Site Plan Review For Ypsilanti Township, Michigan

Applicant:	Crown Enterprises
Project Name:	Hercules Concrete Plant
Plan Date:	August 3, 2021
Location:	2555 State Street, Ypsilanti Twp
PID:	K-11-13-256-002
Zoning:	I-C, Industrial and Commercial Districts
Action Requested:	Final Site Plan Review.
Required Information:	As noted in this report.

RE: Hercules Concrete Plant 2555 State Street Site Plan Review #1

> Re: Preliminary (non-residential) Site Plan Review #1 Hercules Concrete Plant Charter Township of Ypsilanti (Plan Date: 08-03-2021)

PROJECT NO: 2021-100SCALE: NTSDRAWN BY: M. K.CHECKED BY: F. K.PROJECT MGR: F. K.APPROVED BY: F. K.
SHEET TITLE SITE DETAILS
SHEET NUMBER ISSUE
CS-500

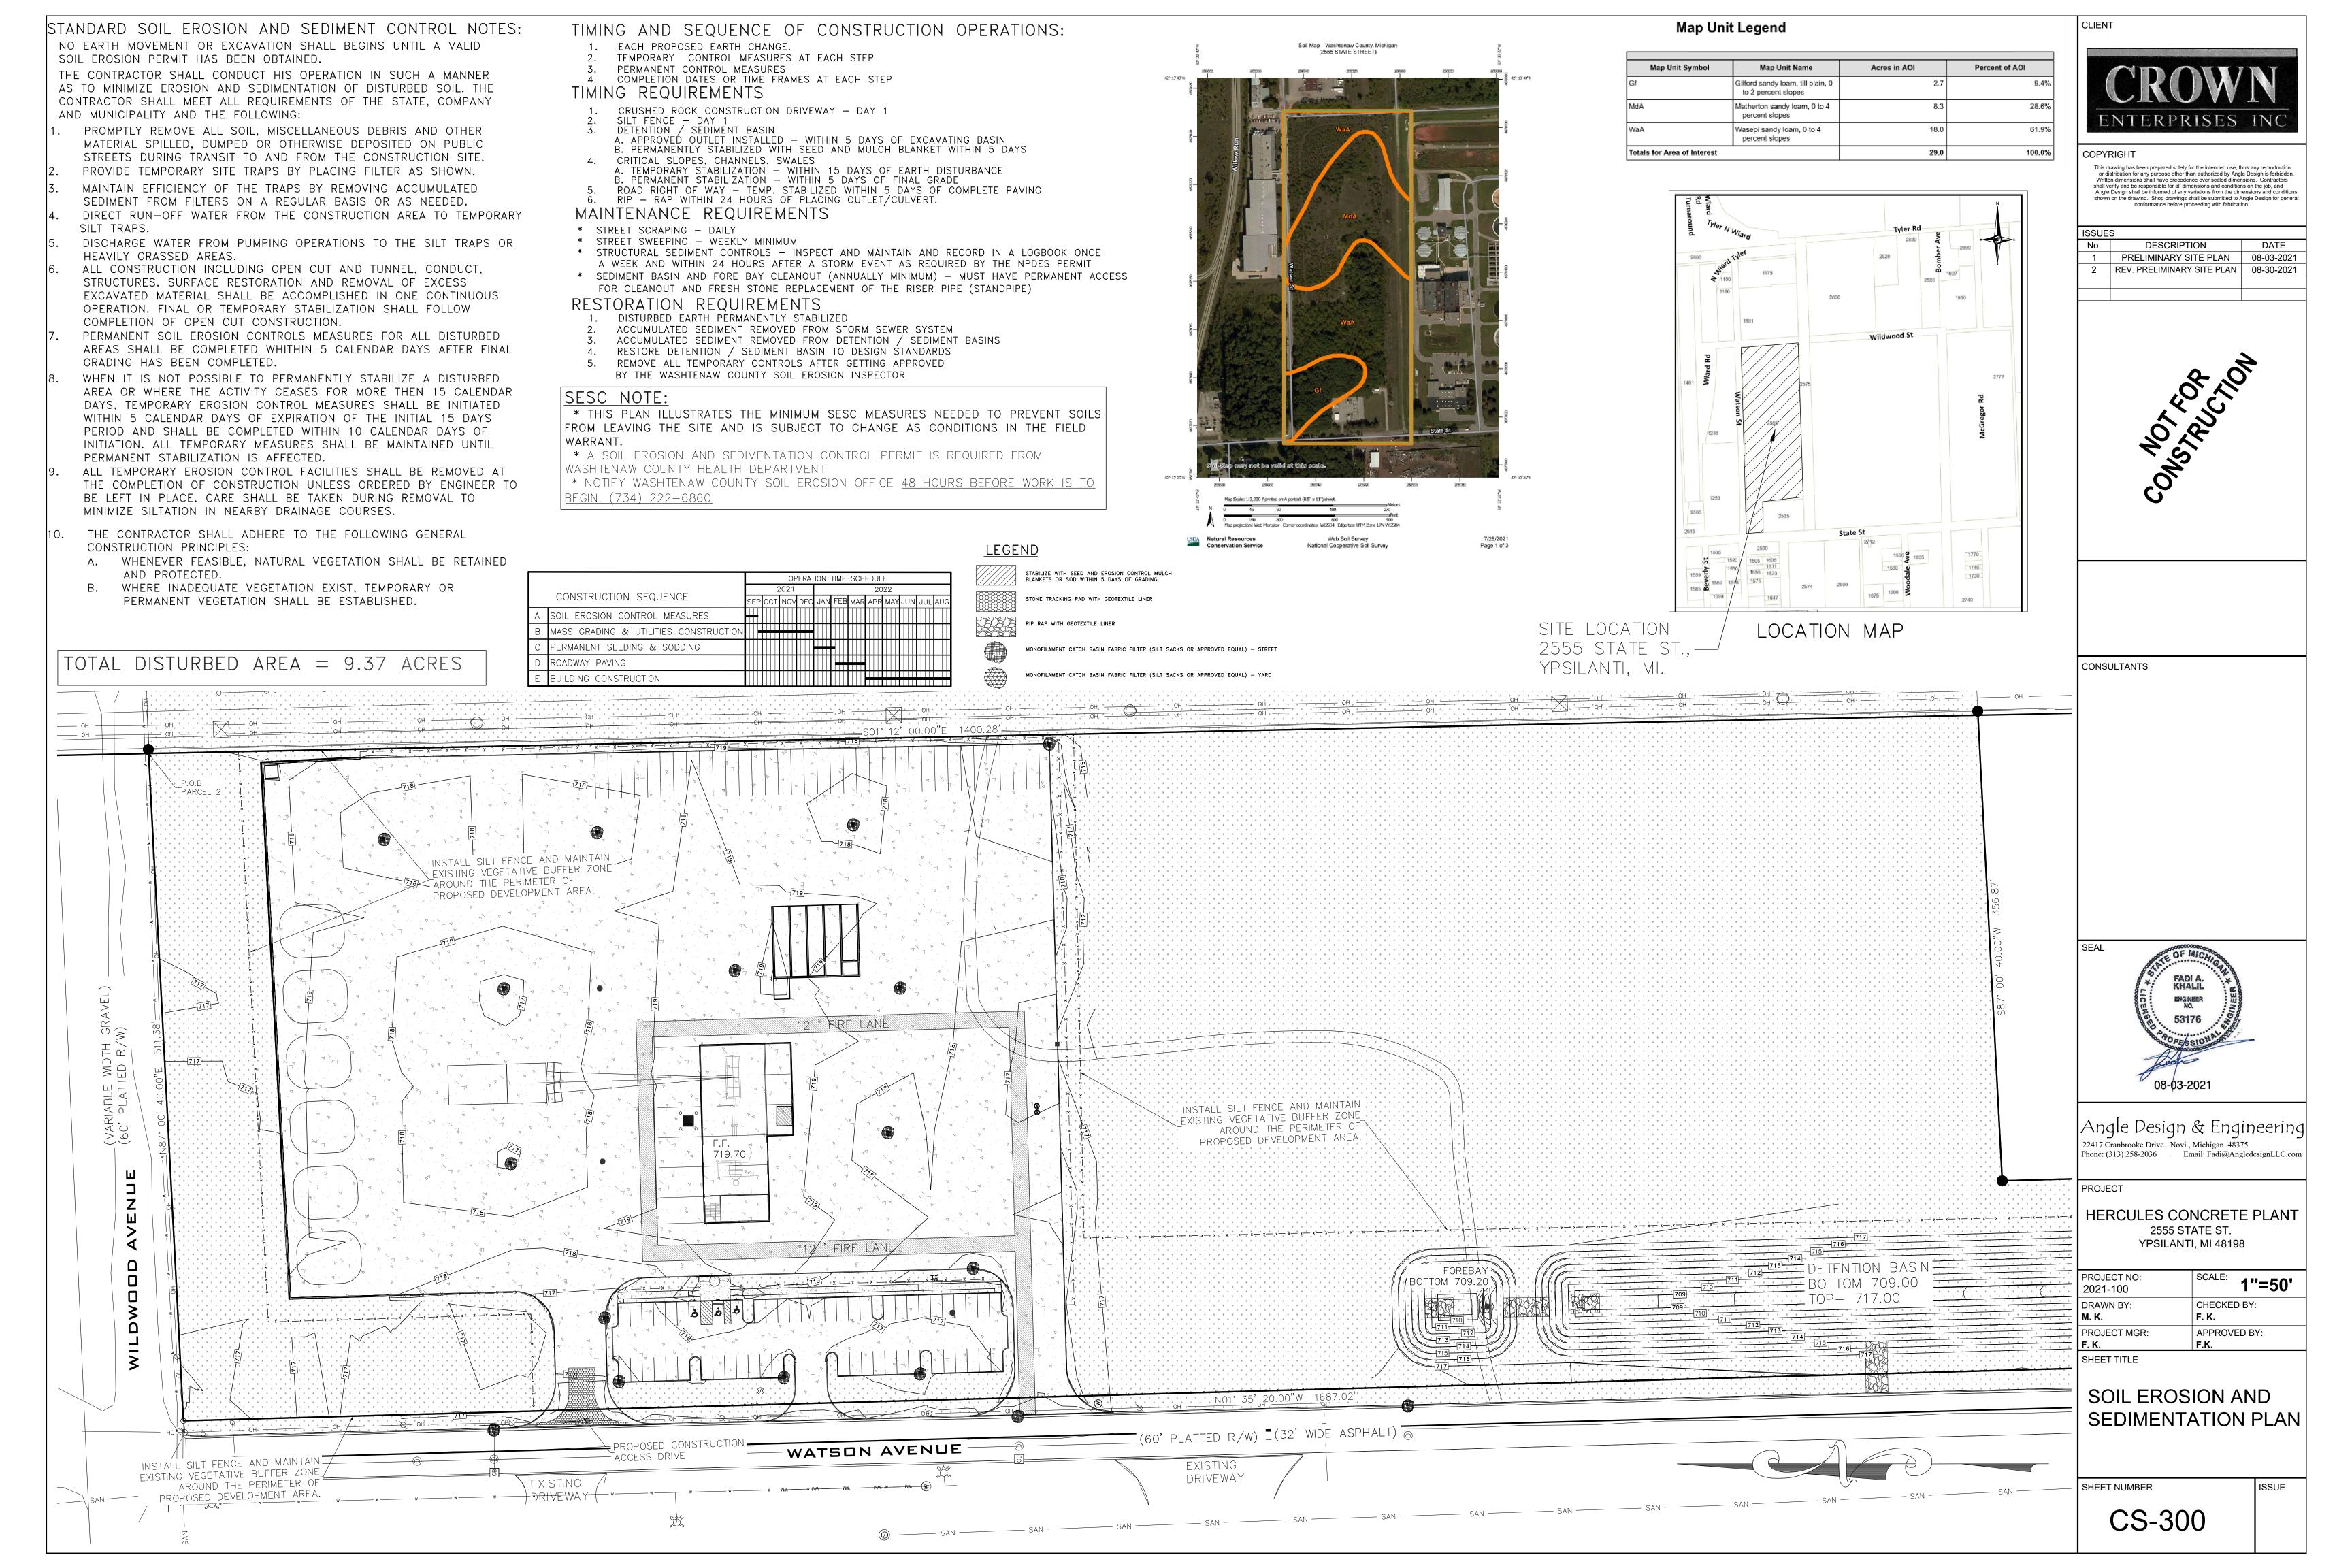
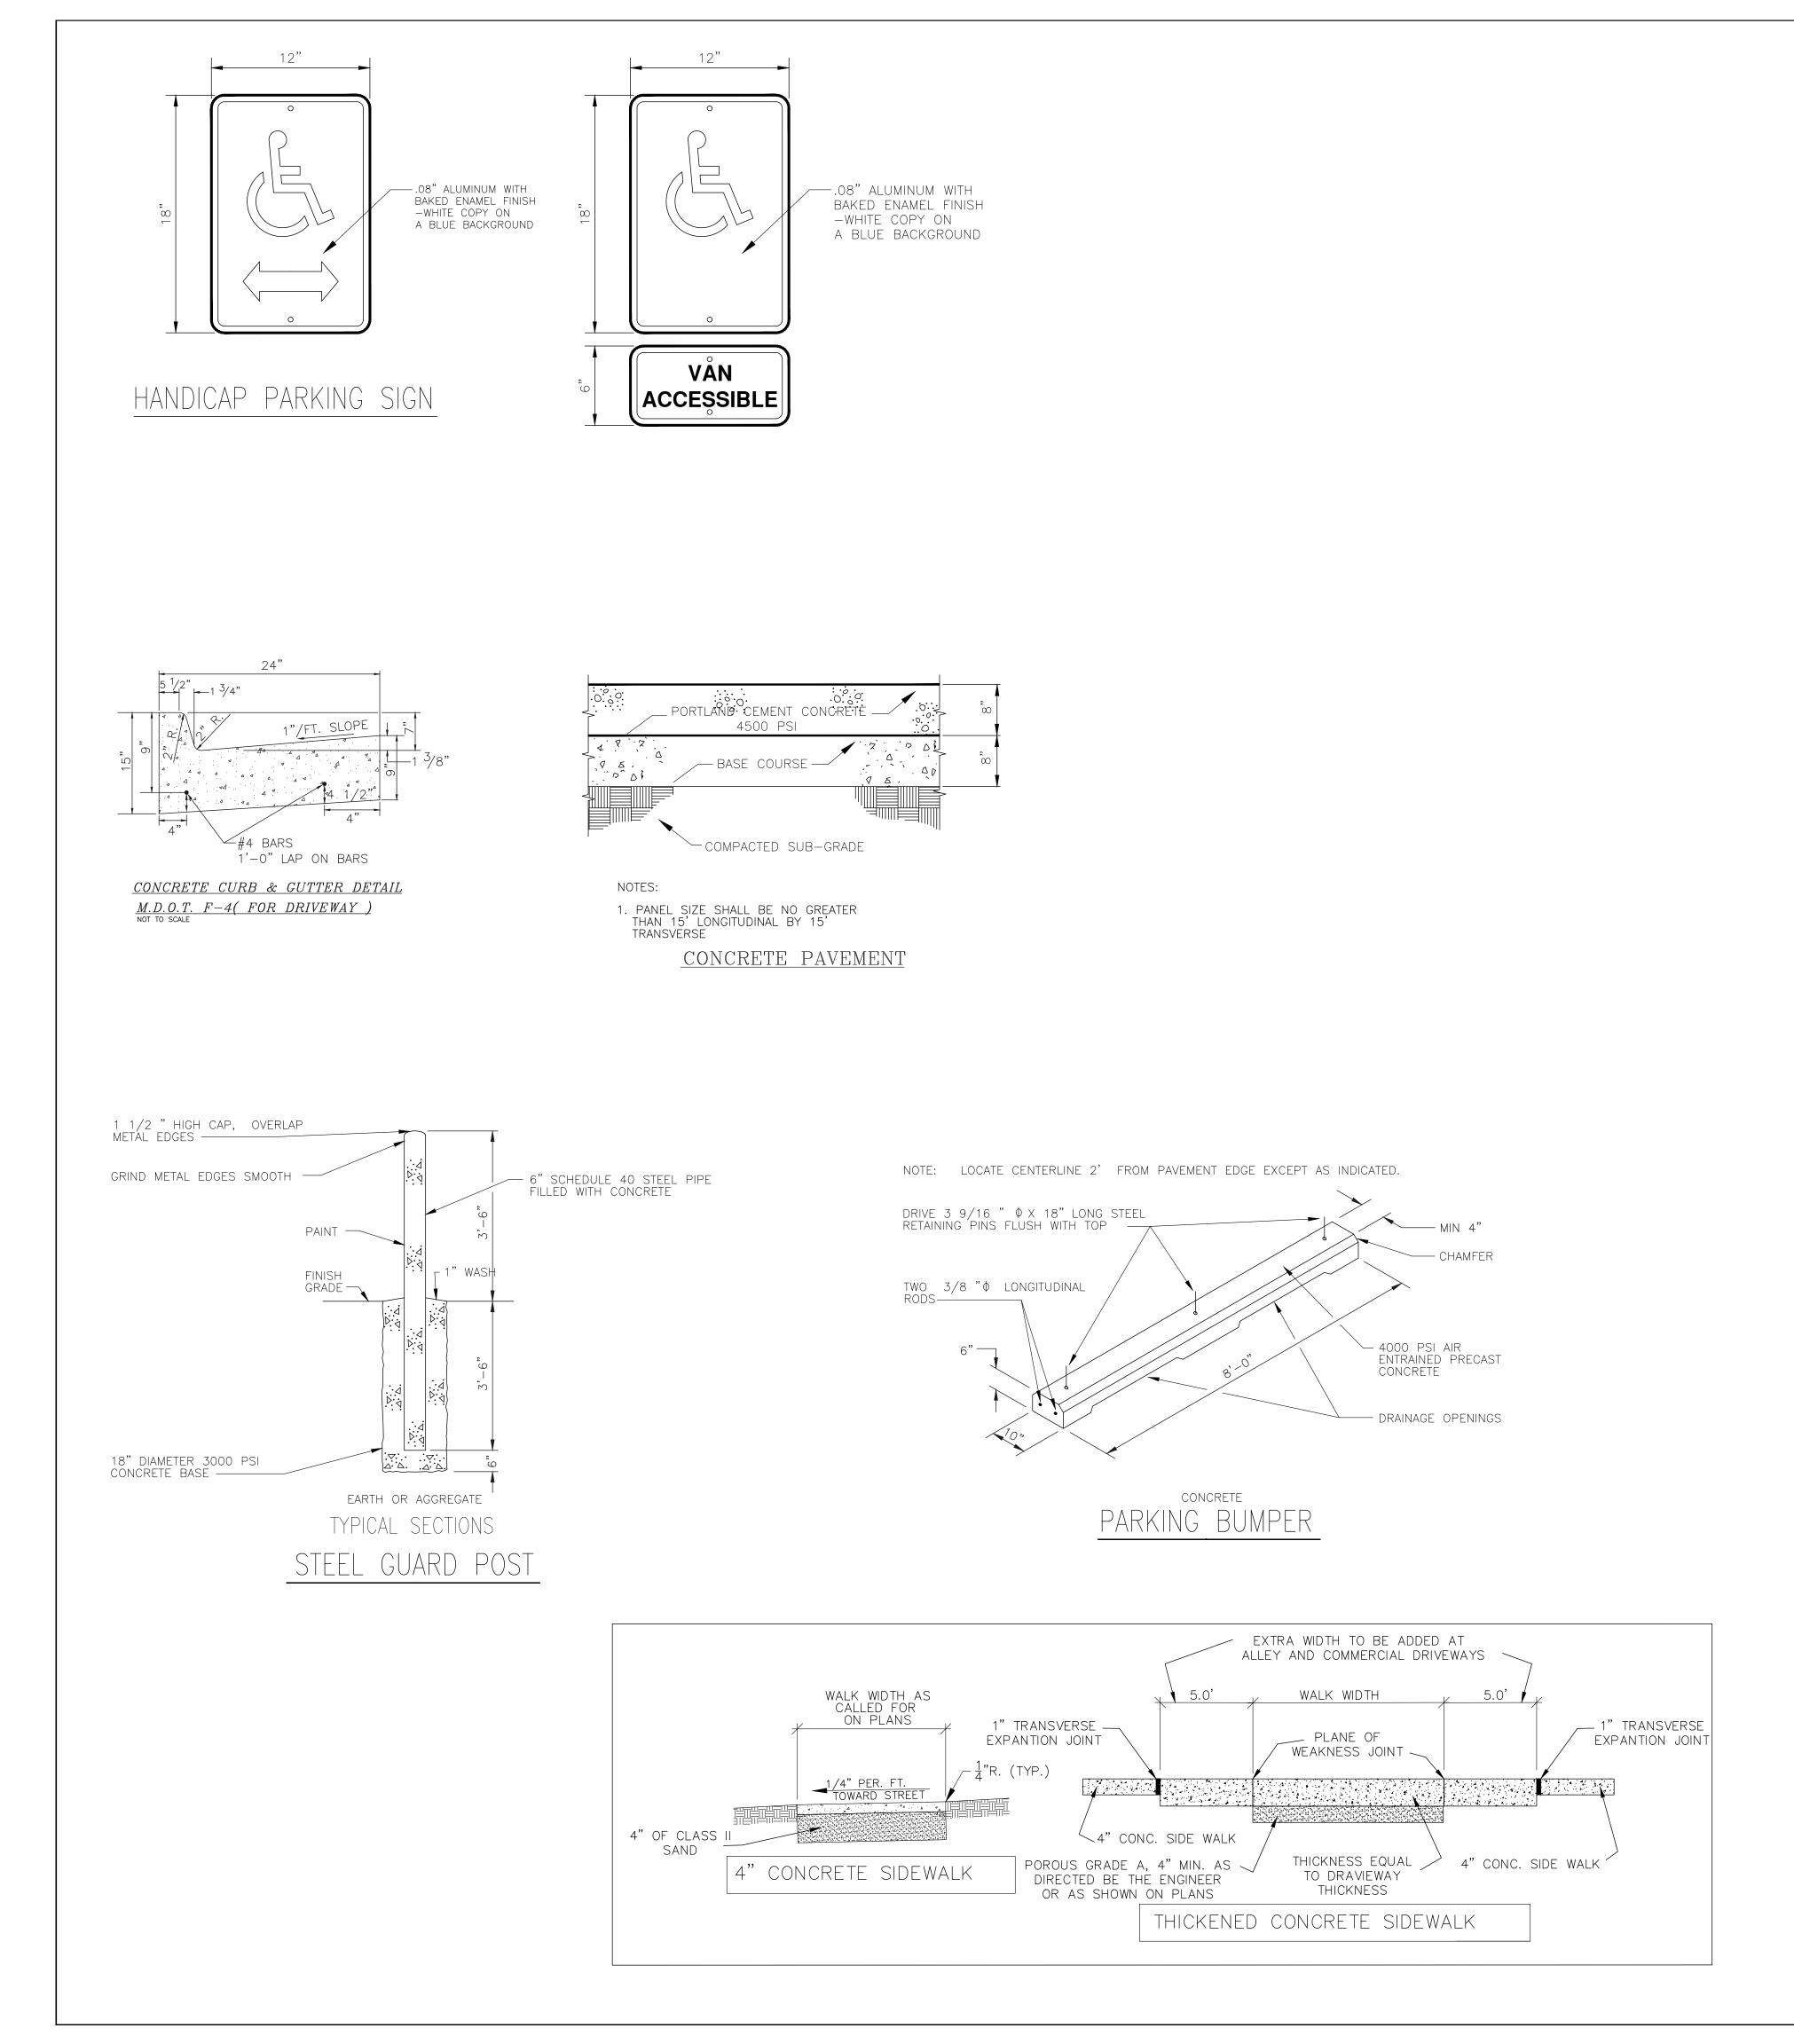
- 6. The applicant shall provide a cross-sectional detail for the proposed truck washing station or note the appropriate proposed detail.
- 7. The applicant shall update the 4-inch sidewalk cross-sectional detail to include four (4) inches of Class II sand in addition to the concrete in the detail.

- 8. The applicant shall provide specification for the proposed PCC (ie. 3500 PSI) and a detail of base course used in the concrete cross section, found on sheet CS-500.

LP - 1: LANDSCAPE PLANTING PLAN * Base data provided by Angle Design & Engineering, L.L.C.

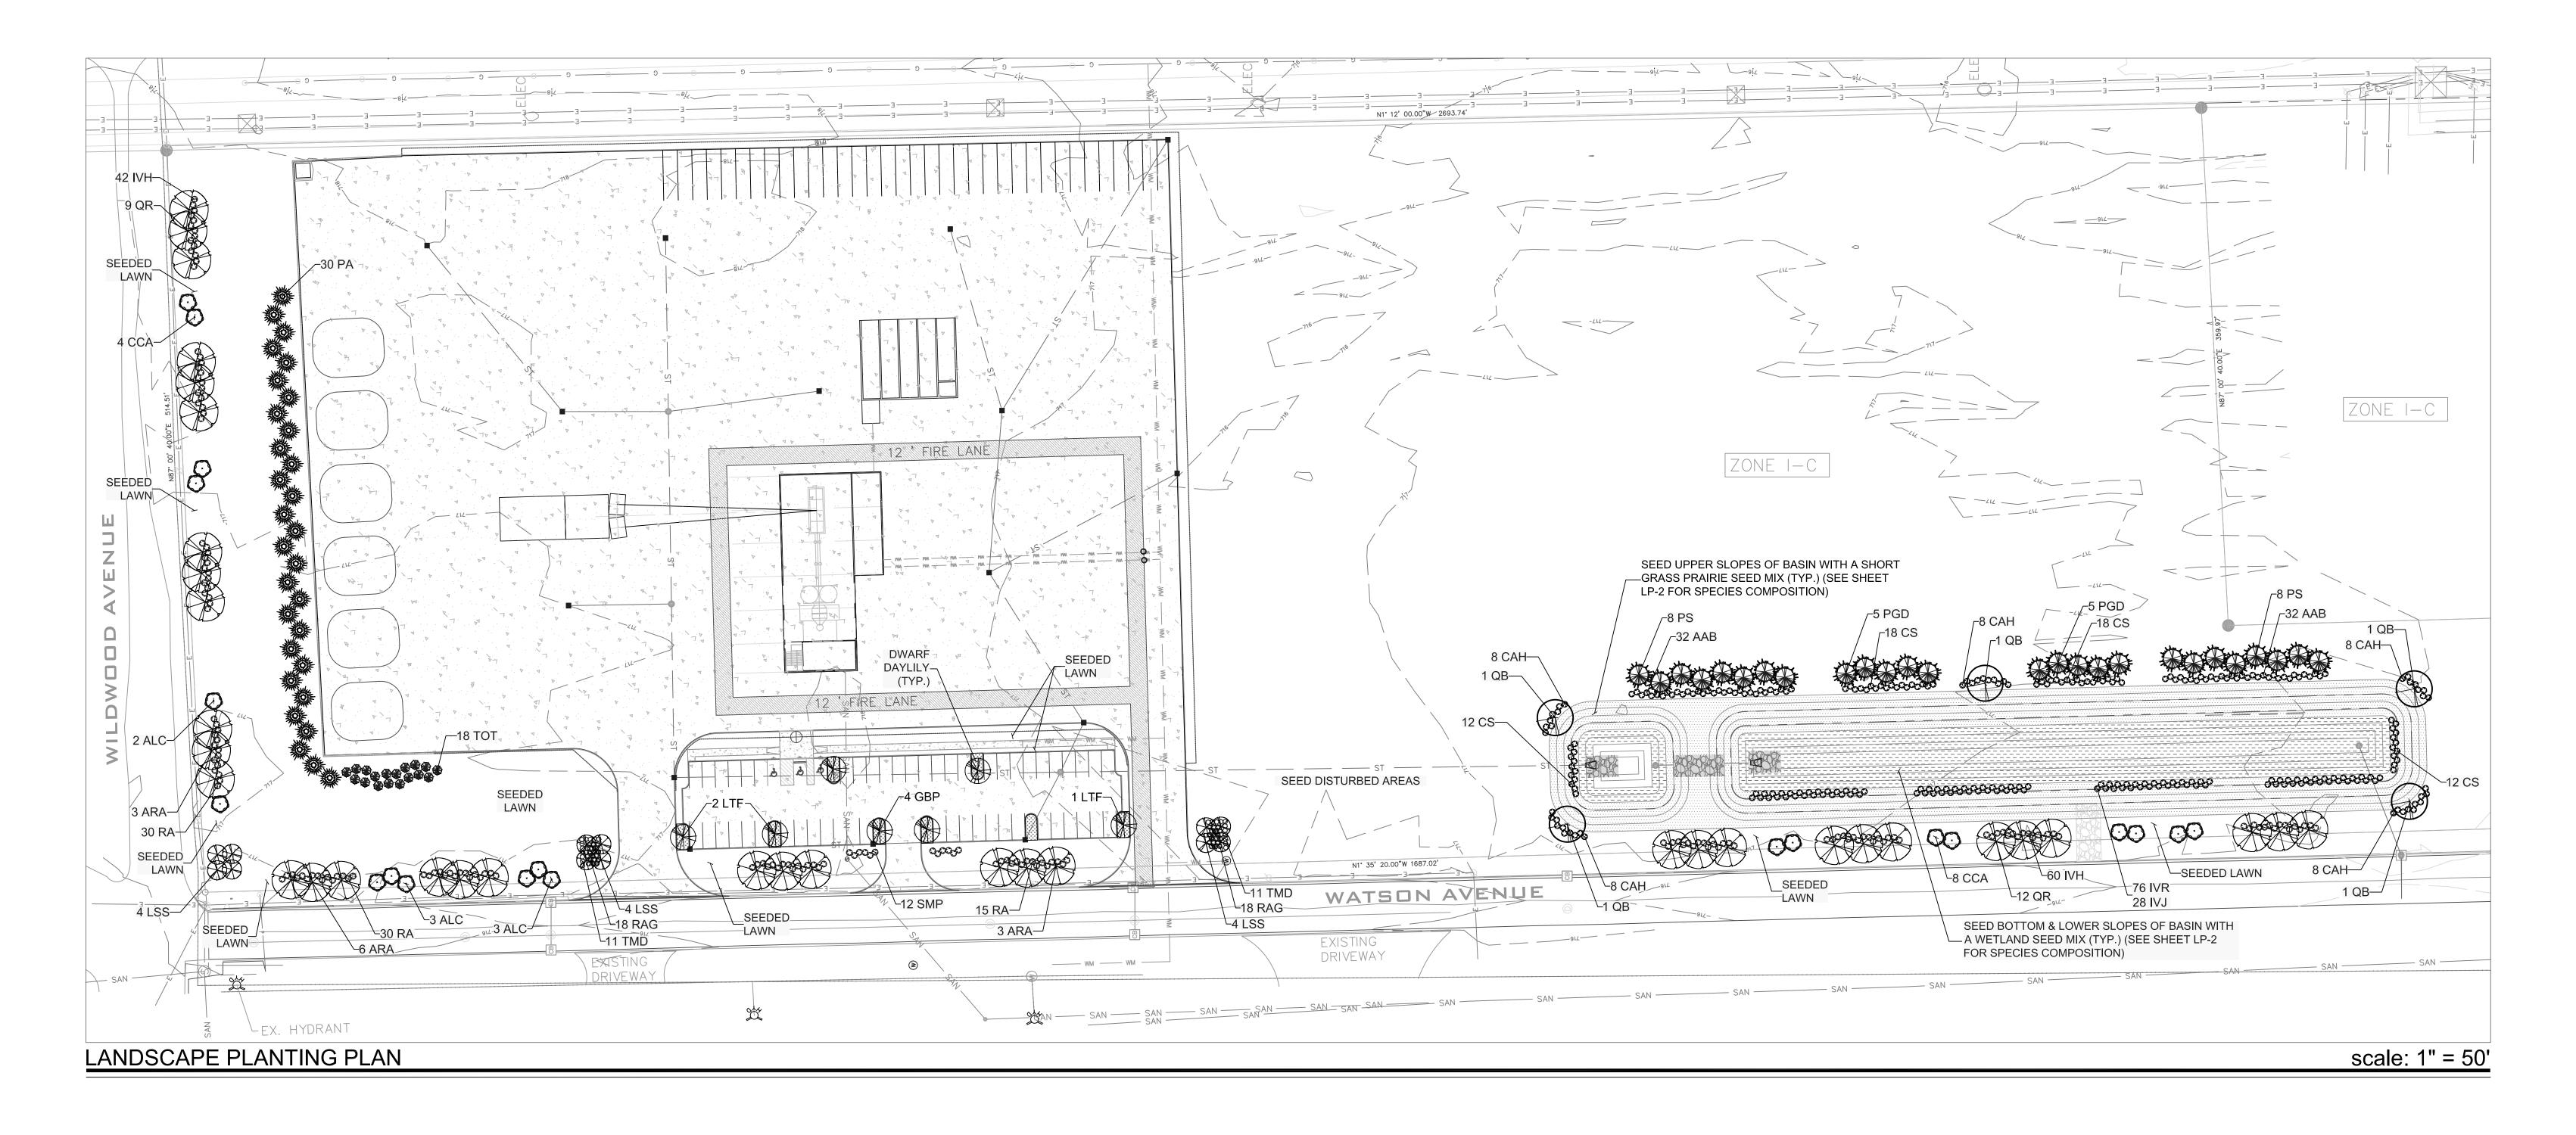
Parking Lot Landscaping: One (1) large deciduous tree shall be required for each 3,000 square feet of paved driveway and parking lot surface, provided that no less than two trees are provided. Trees shall be distributed evenly throughout the parking area. In large parking areas, islands should be approximately every ten spaces. Each tree shall be provided with an open land area of not less than 150 square feet to provide area for infiltration. The applicant provides 7 deciduous trees in the parking lot. The amount of shrubs are not noted on the landscape plan and refers to the landscape contractor for the quantity of Happy Return Daylilies. The applicant should submit all landscaping information for final site plan review.

Items to be Addressed: The applicant should submit all landscaping information for final site plan review.

1. It currently appears that the proposed sanitary sewer locations on the utility plan sheet and the landscaping sheet differ. The applicant shall ensure there is no direct conflict between proposed trees and the proposed underground infrastructure and revise accordingly.
